Chapter 11. Dwelling Units and Sleeping Units

DRAFT

Figure 1104.9 Exception 12

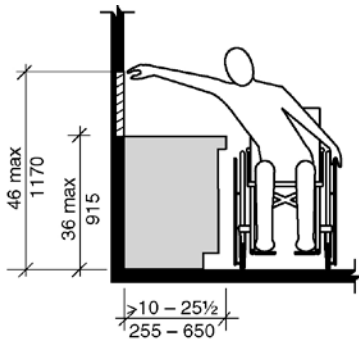
7. Controls mounted on ceiling fans.
8. Controls or switches mounted on appliances.
9. Plumbing fixture controls.
10. Reset buttons and shut-offs serving appliances, piping and plumbing fixtures.
11. Where redundant controls other than light switches are provided for a single element, one control in each space shall not be required to be ~~accessible~~, comply with this section.
12. Within kitchens and bathrooms, lighting controls, electrical switches and receptacle outlets are permitted to be located over cabinets with counter tops 36 inches (915 mm) maximum in height and 25-1/2 inches (650 mm) maximum in depth.
(Note: #1 - reach did not change, so delete)
(Note: Editorial #60 – match NEC language)
(Note: Cannot remove exceptions here because reference is to 309.3, not 309.1 where the exceptions are located.
